THE HOTEL AT FOUNDRY PLACE, "LOT 3": 165 DEER STREET, ASSESSORS MAP 125 LOT 17, AND RELATED IMPROVEMENTS TO LOTS 2, 4 & 5

SITE PLAN REVIEW

SITE PLAN REVIEW
FEBRUARY 6, 2018

**VEHICLE
TURNING
EXHIBIT**

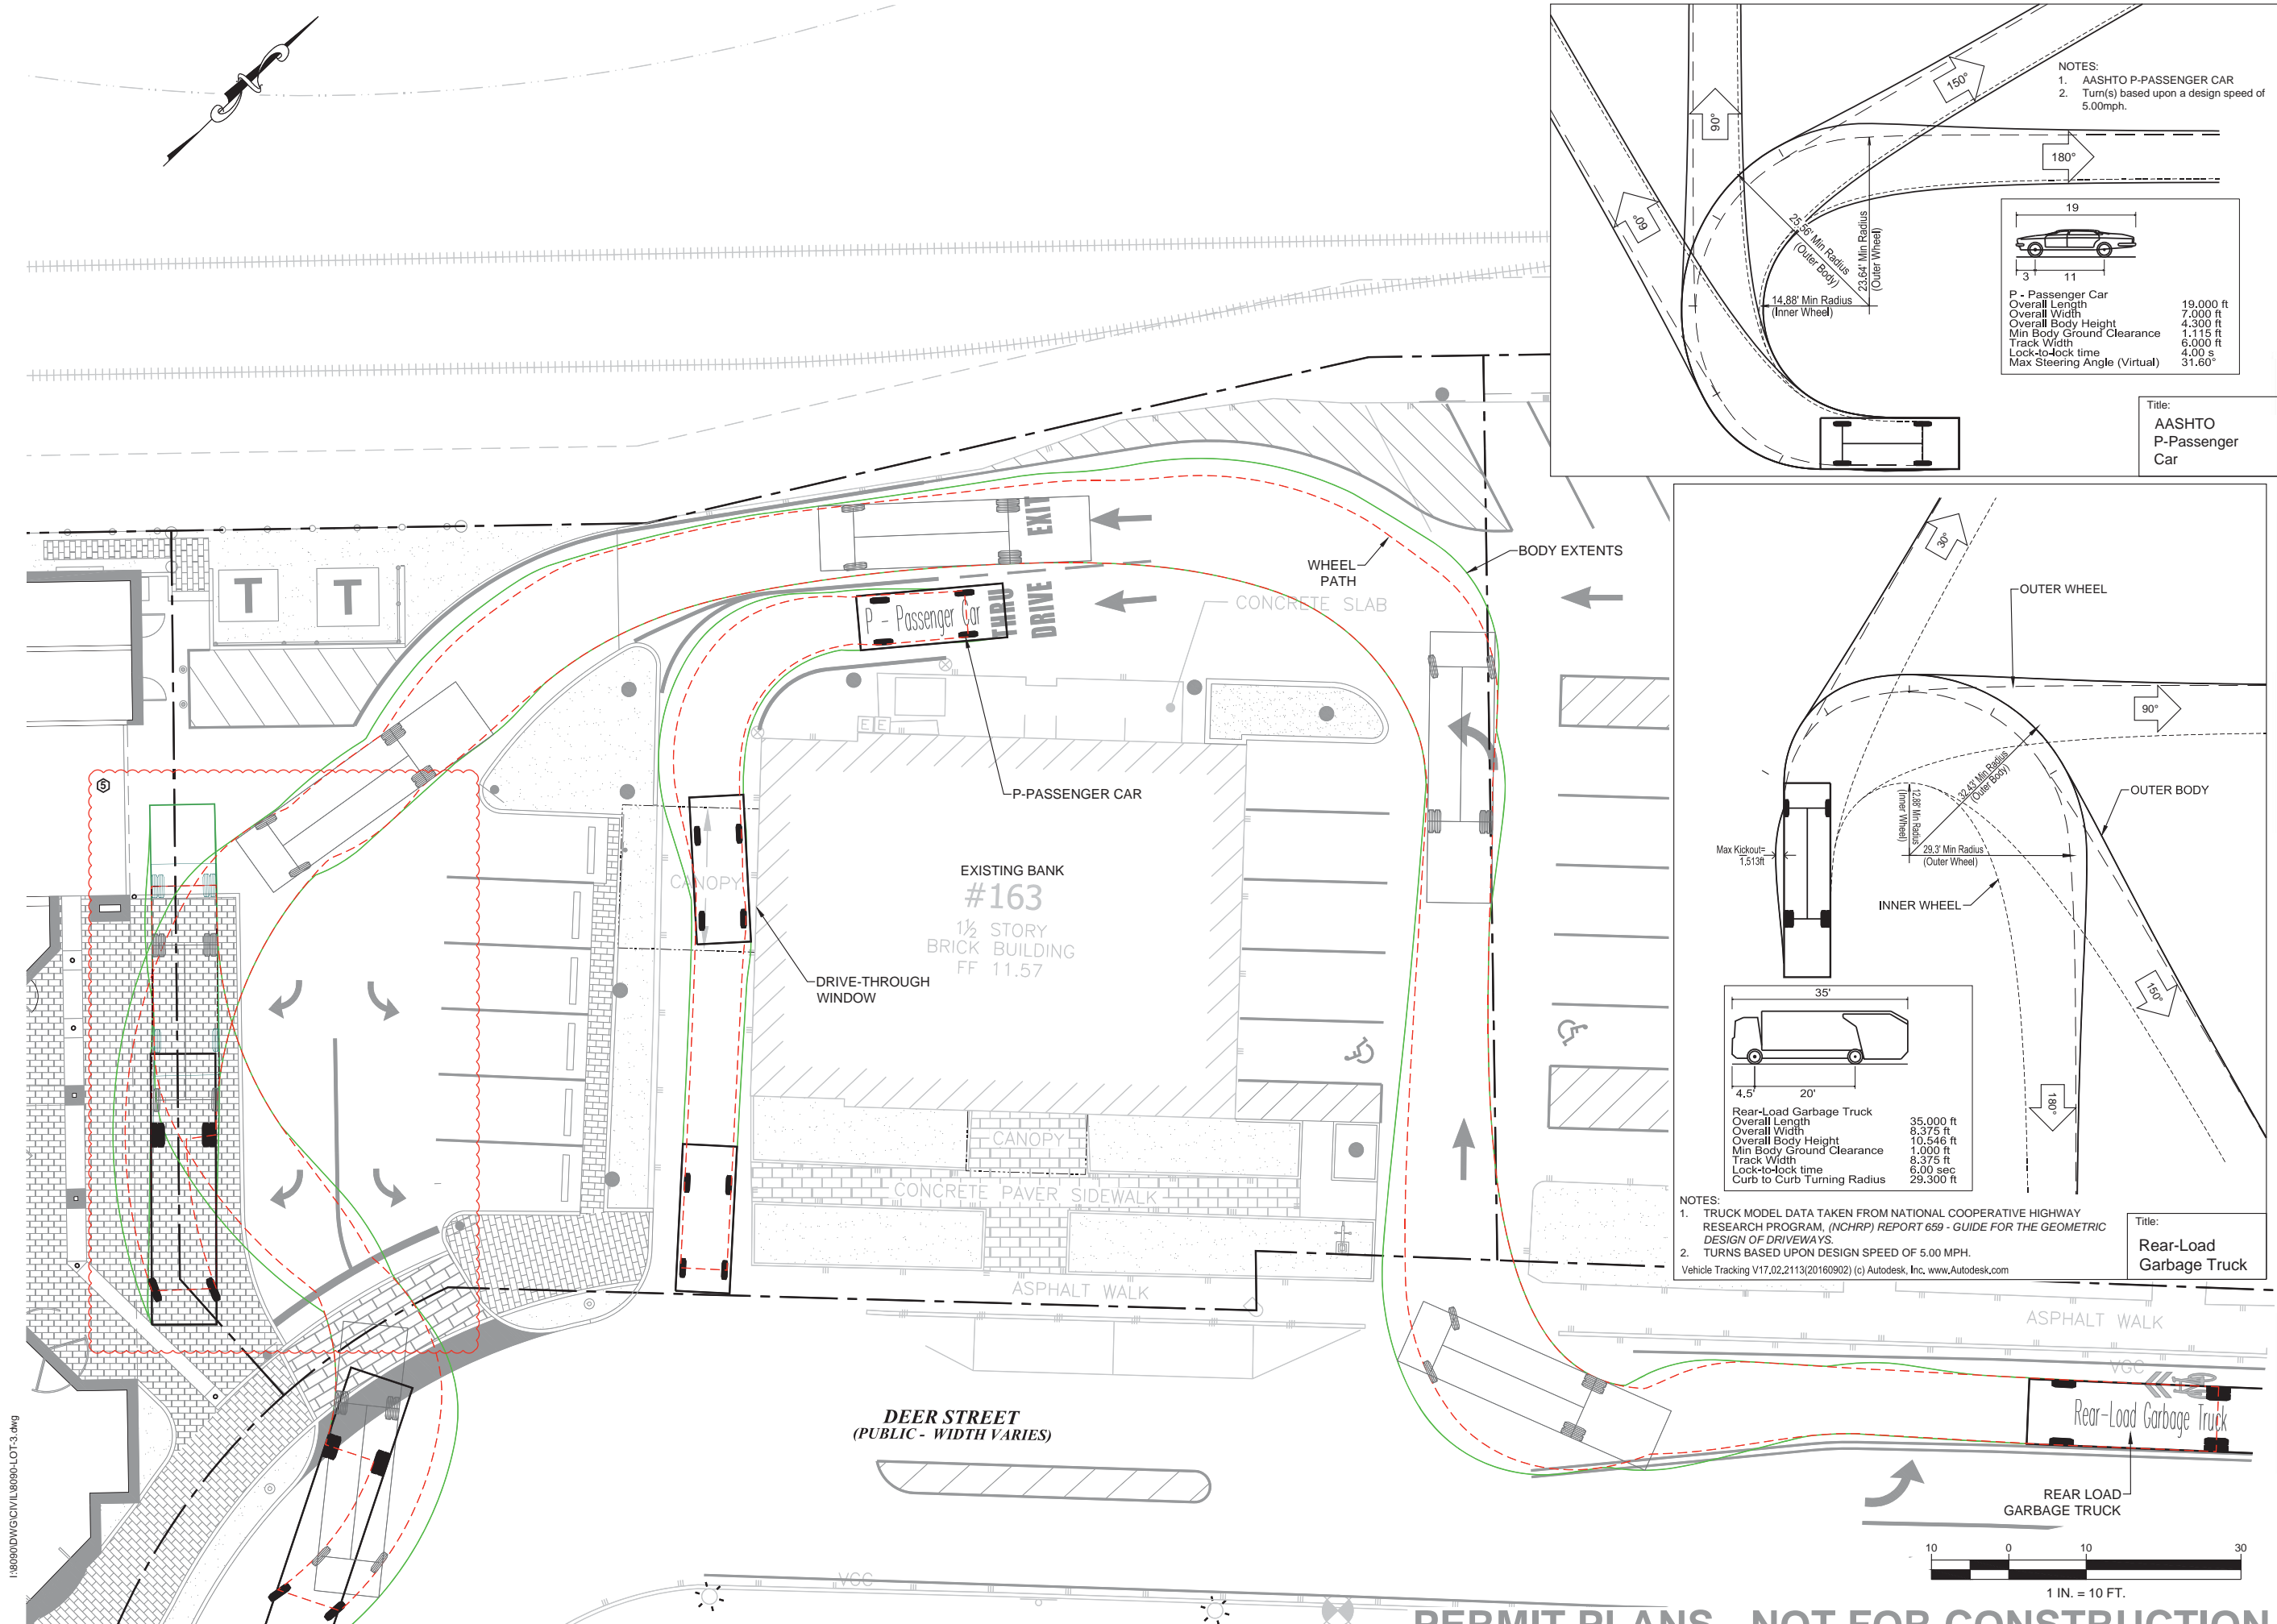
Response: The Hotel operator will be responsible for scheduling trash pickups and hotel deliveries for off peak hours. Wheeled trash containers will be stored in the trash room located in the garage, and wheeled out to the garage entrance at time of trash pickup. The Hotel operator will notify vendors that the largest size delivery truck allowed will be a WB-40 vehicle. See attached Figure C3.6.

**MANEUVERING
PLAN FOR
P-SIZE SIZE
DELIVER VAN**

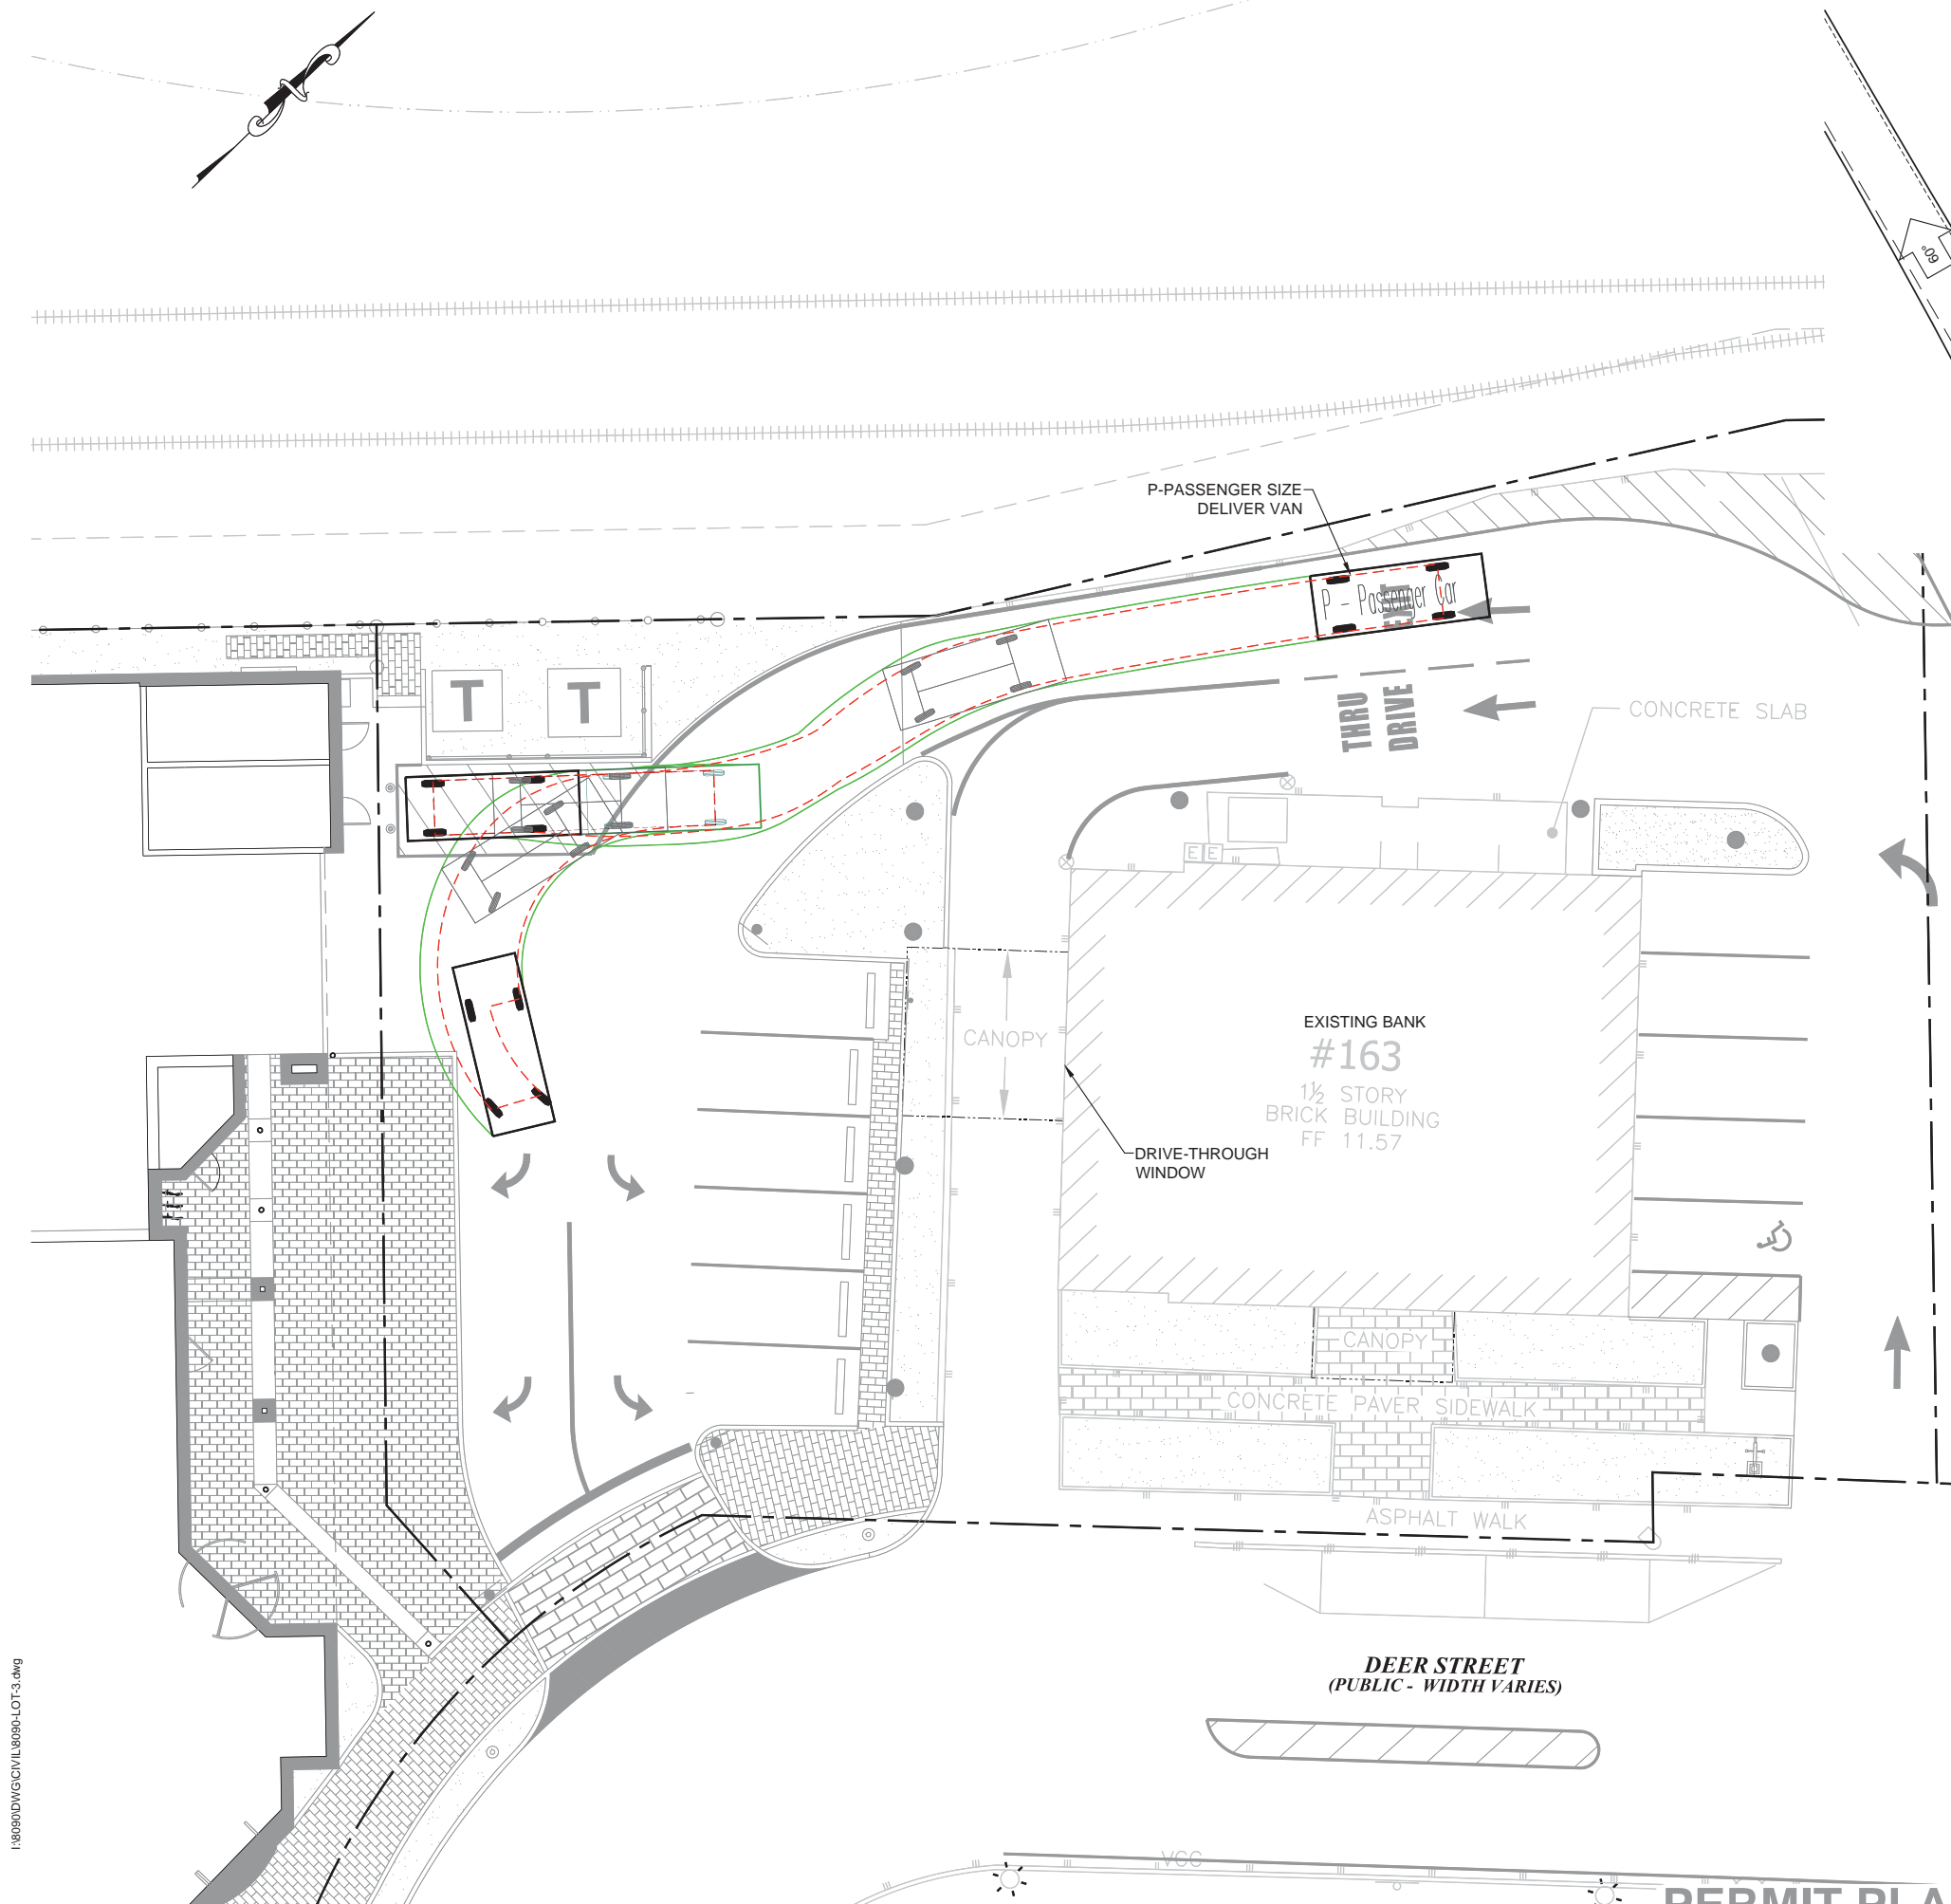
Response: As shown on sheet A1.0IT there is a service door from the garage area that goes directly to the storage and kitchen areas, and service elevator. All larger packages and food items will be delivered through this area. See attached Figure EXB-2.

**SITE PLAN-
DETAIL
(SHEET 1 OF 3)**

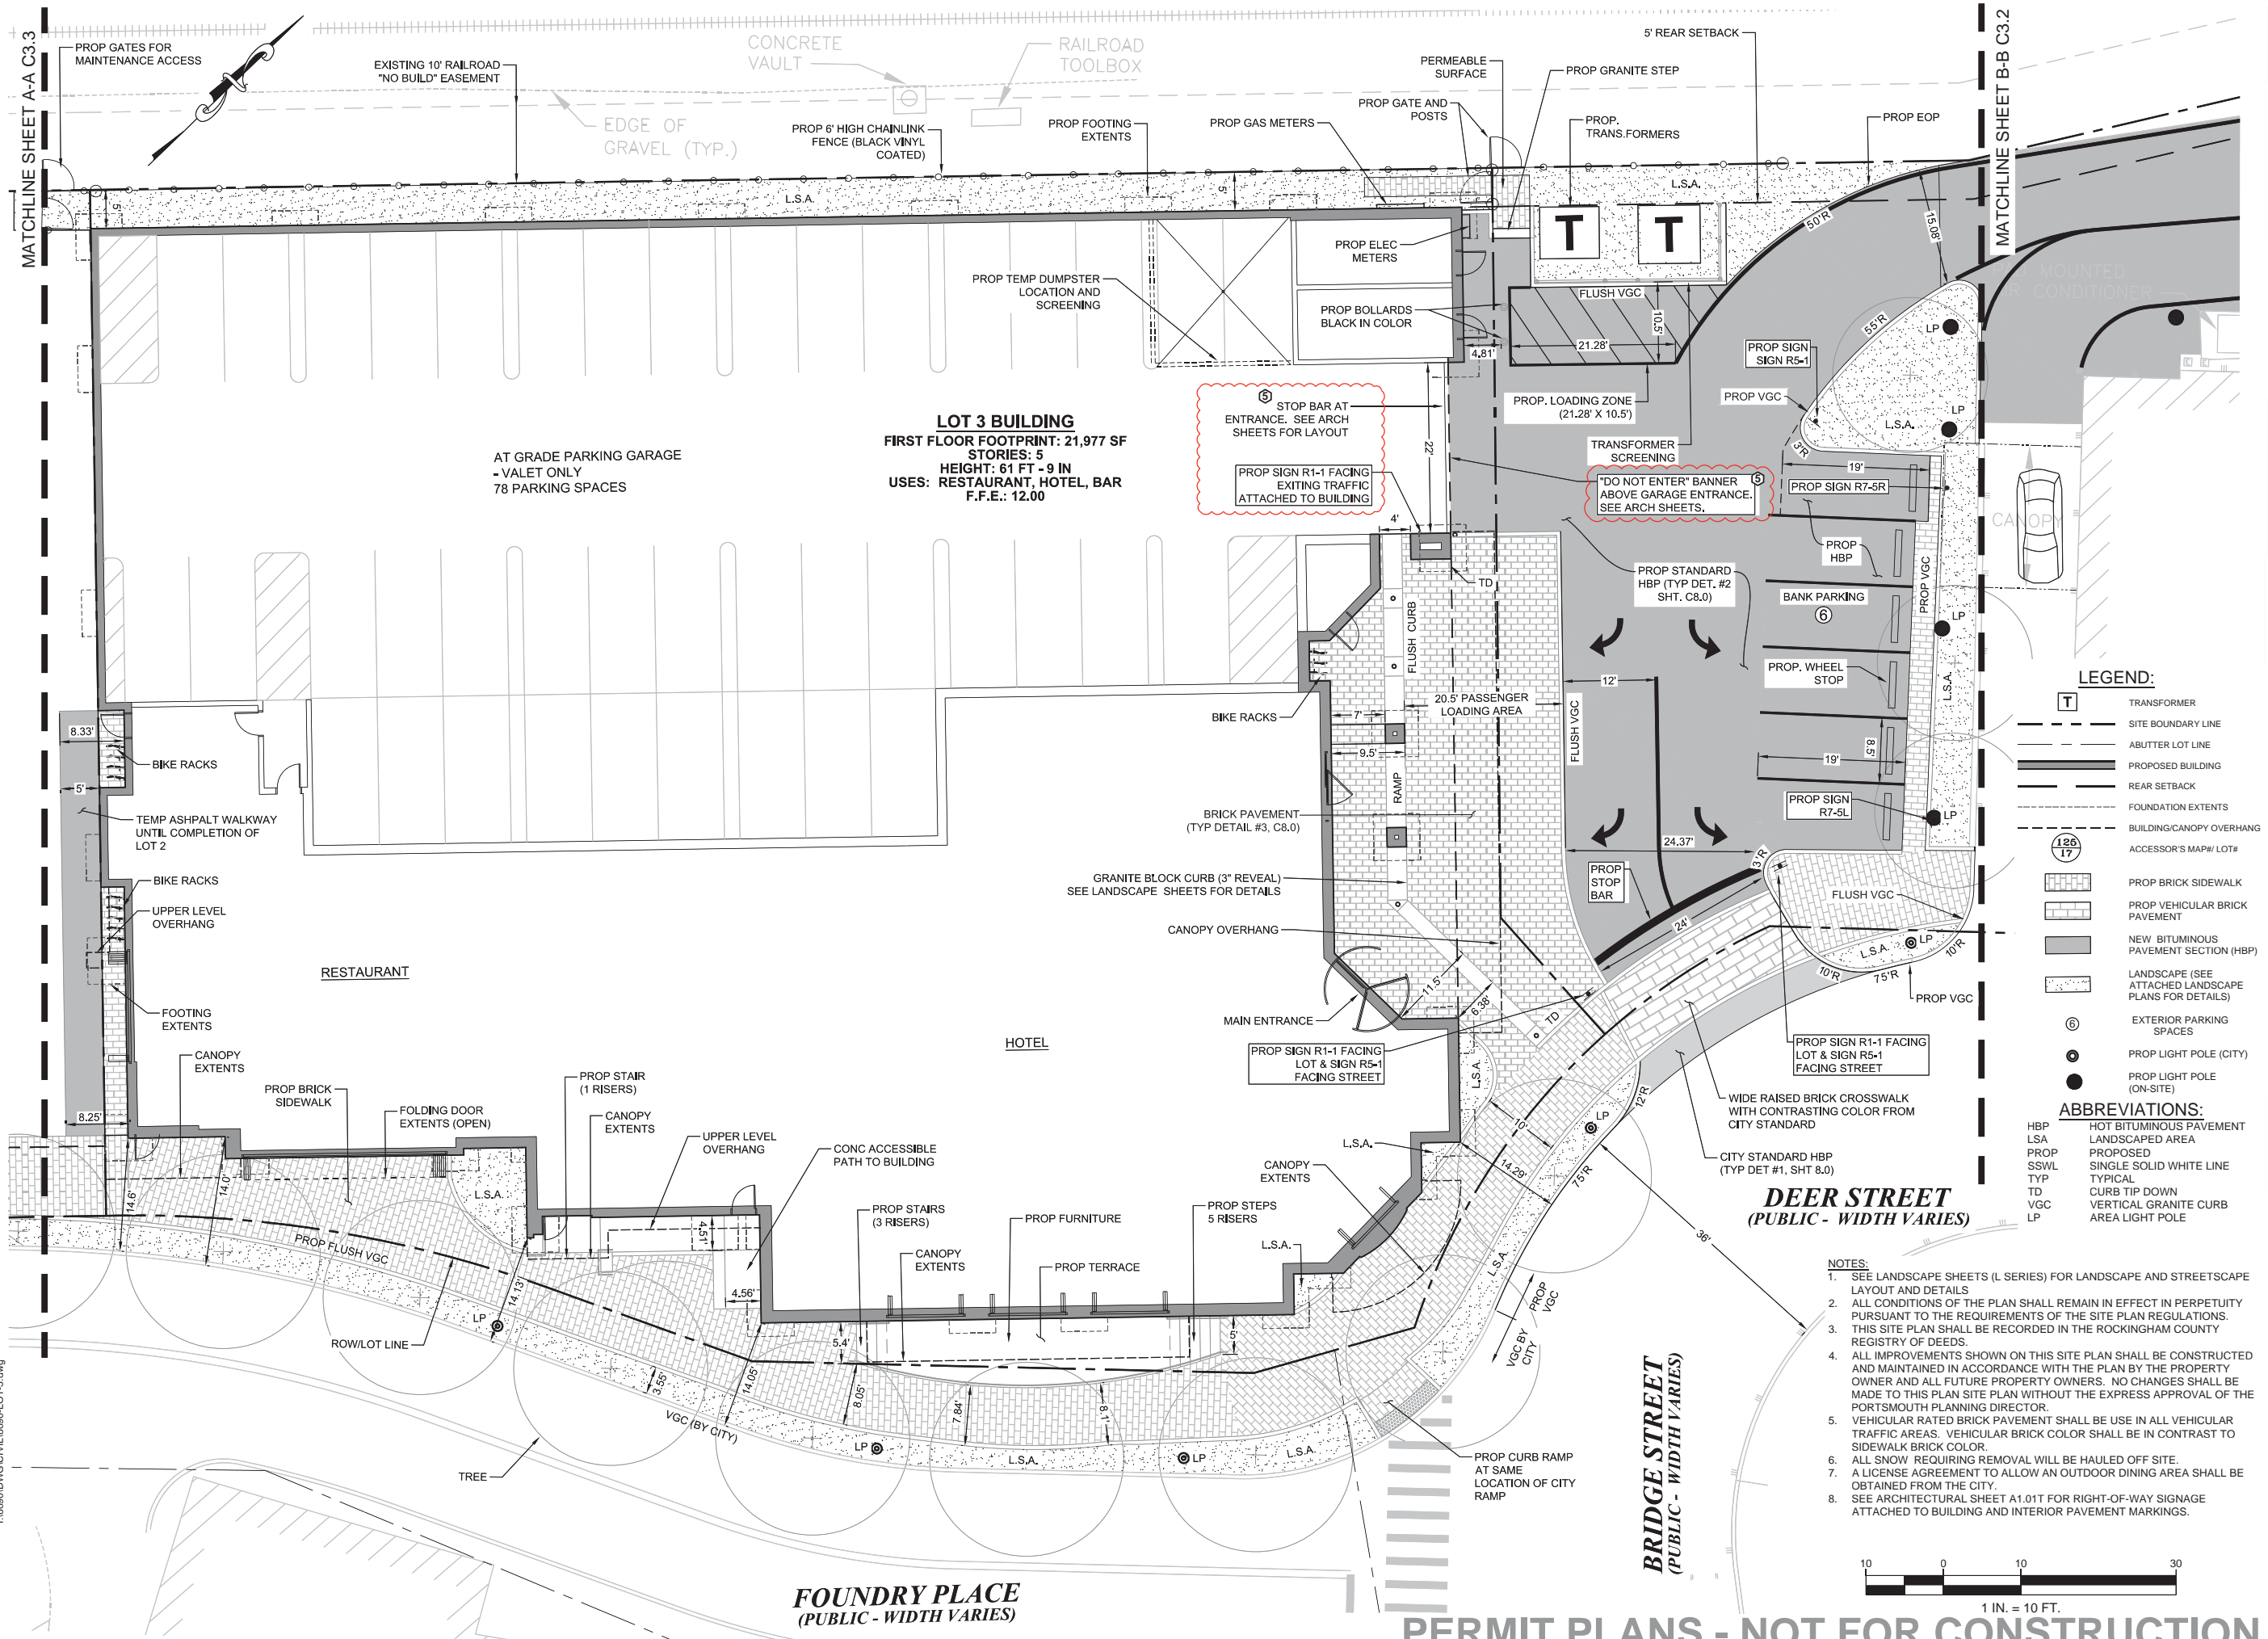
Response: A STOP sign will be erected inside the garage facing exiting traffic and will be supplemented with pavement markings as shown on the attached Figure C3.1.
